Project No. E5999 29 March 1989

Subject: Modification of Proposal for

Environmental Services/Phase I Investigation of Groundwater Contamination for Okata Property

San Leandro, California

FIGURE NO. 1 - SITE LOCATION

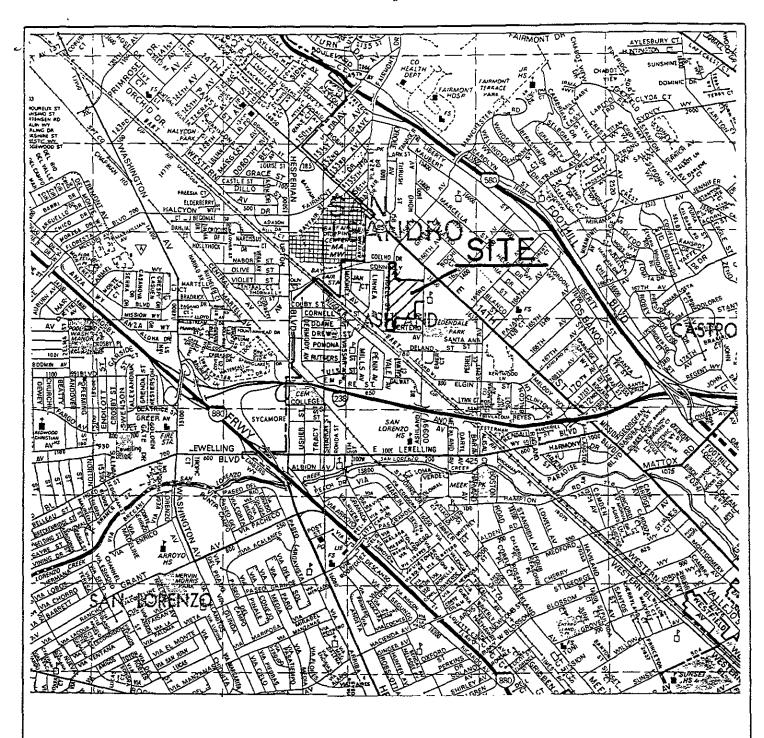
As detailed in Page 2, Paragraph 2, of the above referenced proposal, MW-2 was to have been placed approximately 100 feet south-southwest of the gasoline tank excavation.

As I discussed with you yesterday, we had intended to modify this and place MW-2 down gradient of the oil tank exavation due to a larger concern over the contaminants observed in this pit. Unfortunately, at the present point in time, the accessibility to this anticipated location is minimal, and a change in location for MW-2 is again required.

As currently planned, MW-2 is to be located approximately 500 feet southwest of the gasoline excavation.

Please find enclosed with this letter a copy of the anticipated monitoring well locations for MW-1 and MW-2.
